## Equipment Technical Bulletin

### DF1 / DF2 / DFT – Smart pump / transport pump screws change

Fig 1. Example pump head with new screws

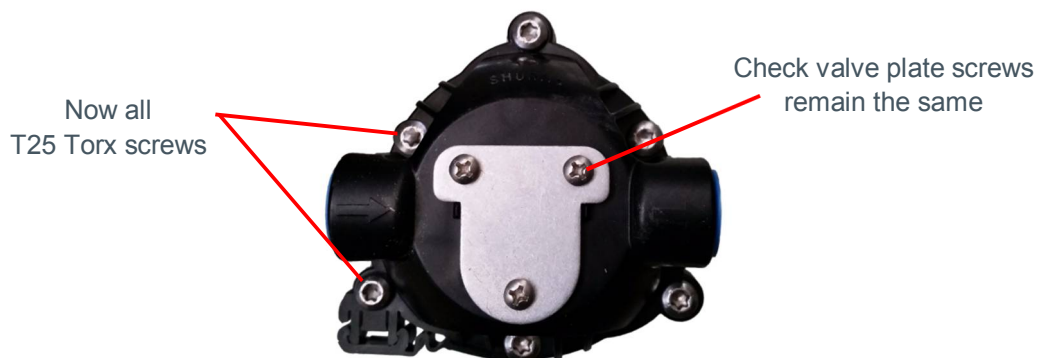
The vendor of the transport pumps Shurflo, as used in the Diverflow laundry systems has begun to use different screws to assemble the pump head assembly. This is a manufacturer upgrade to allow them to improve production controls.

The new screws will be visible in new pumps and spares, a Torx screw with T25 head (fig 1) replaces the Phillips screw currently in place.

This ETB is published to inform field representatives to be equipped with a T25 Torx driver when visiting sites to service this equipment. No further action is needed.
